NOTICE OF DECISION

**CLASS 3 SITE PLAN REVIEW / CLASS 2 ADJUSTMENT / CLASS 2 DRIVEWAY
APPROACH PERMIT CASE NO.: SPR-ADJ-DAP20-42**

SUMMARY: Proposed development of a pump station on proposed lot 148, with an adjustment request to increase the maximum height allowance for a fence from 4 feet to 7 feet.

LOCATION: 255 Cordon Road NE, Salem OR 97301

PUMP STATION LANDSCAPE PLAN

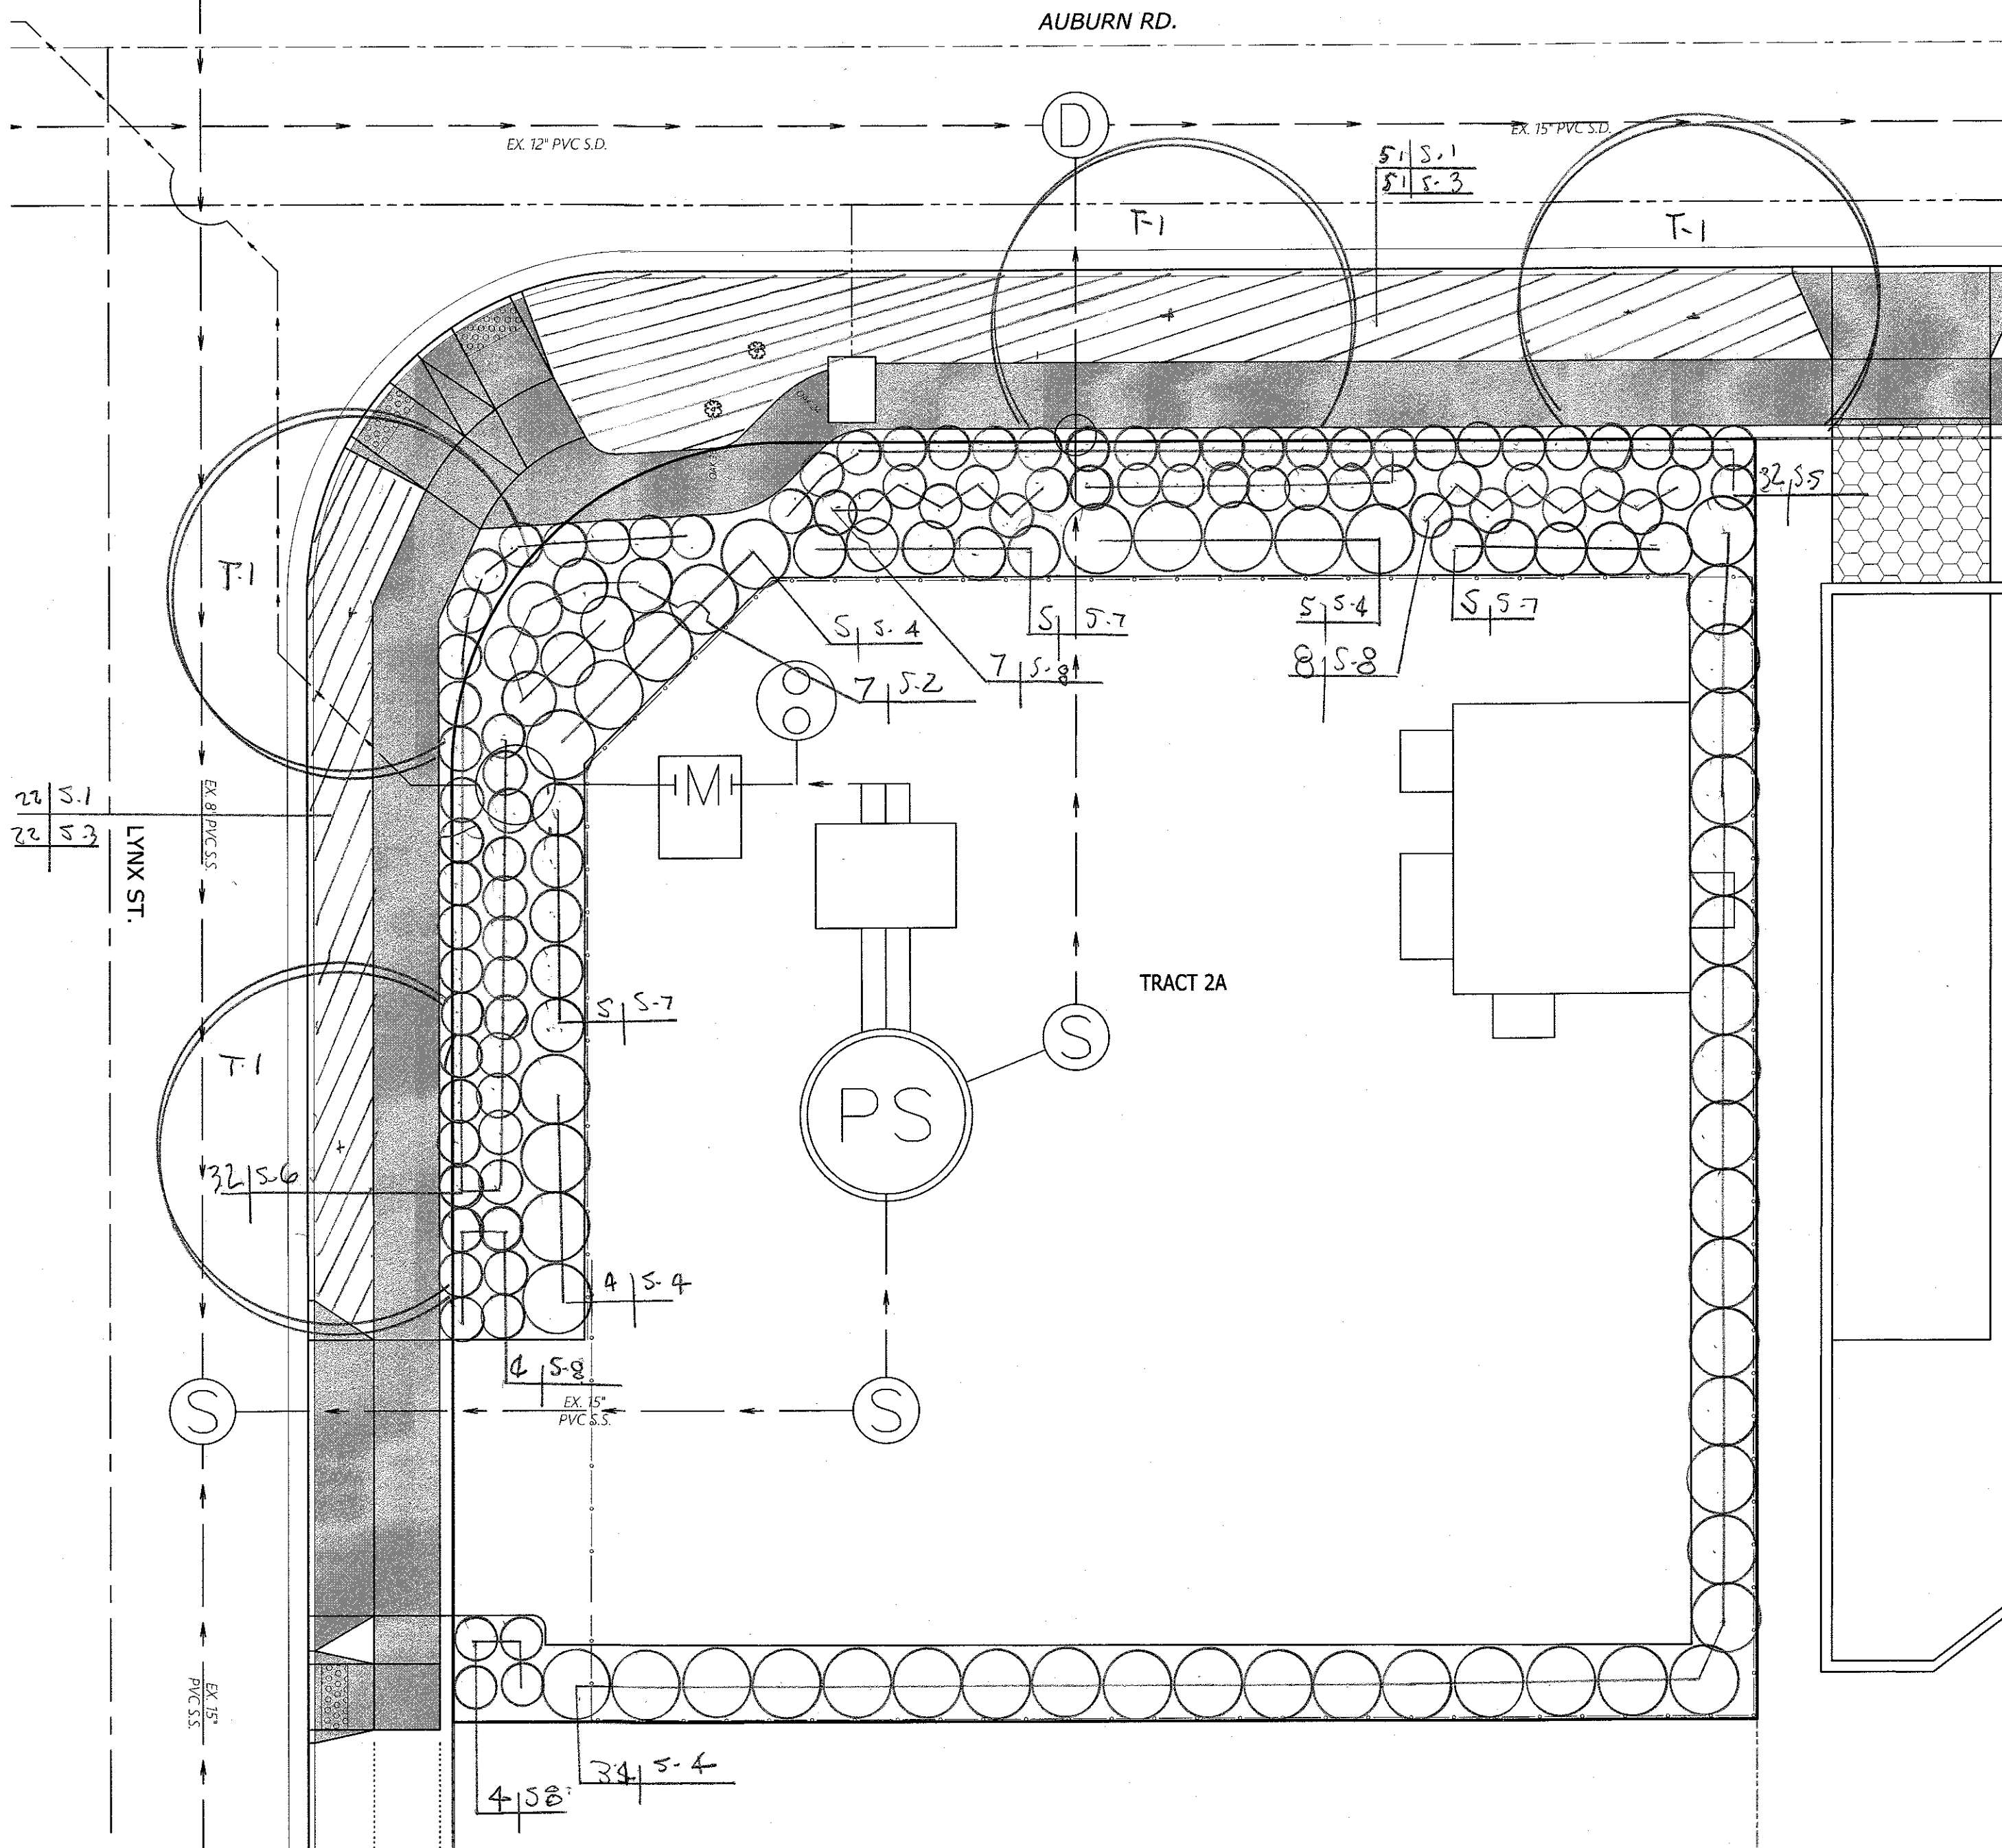
The applicant will be providing landscaping in the 12-foot setback area between the property line and the fence to help screen the property. However, on the landscape plan provided, there are no trees provided in this area. As a condition of approval, the landscape plan shall be revised to

Condition 3: The security fencing shall be setback a minimum of 12 feet from Redmond Street NE and Auburn Road NE. The 12-foot setback area shall be landscaped in accordance with the standards of SRC Chapter 807 and shall include a minimum of one plant unit per 20 square feet of landscape area. A minimum of 40 percent of the required number of plant units shall be a combination of shade trees, evergreen/conifer trees, or ornamental trees.
